MILITARY SPECIFICATION

TRANSCEIVER: 10540501

This amendment forms a part of Military Specification MIL-T-60500A(MU), dated 22 September 1970.

FIGURE 3

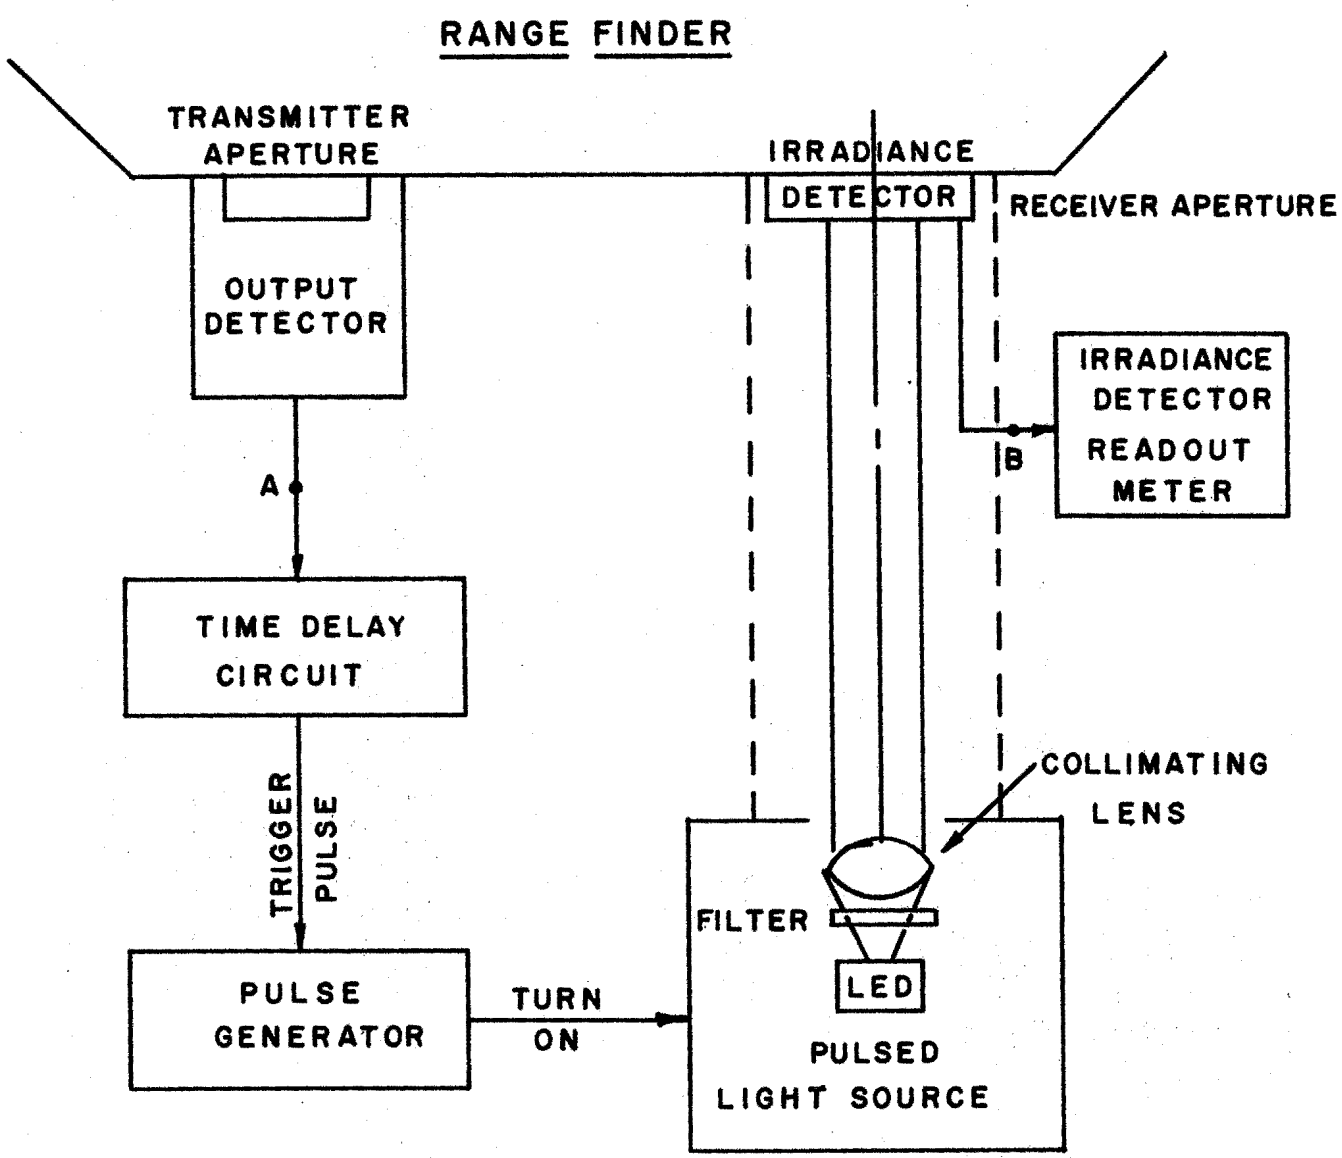
Figure 3: Delete and substitute attached Figure 3.
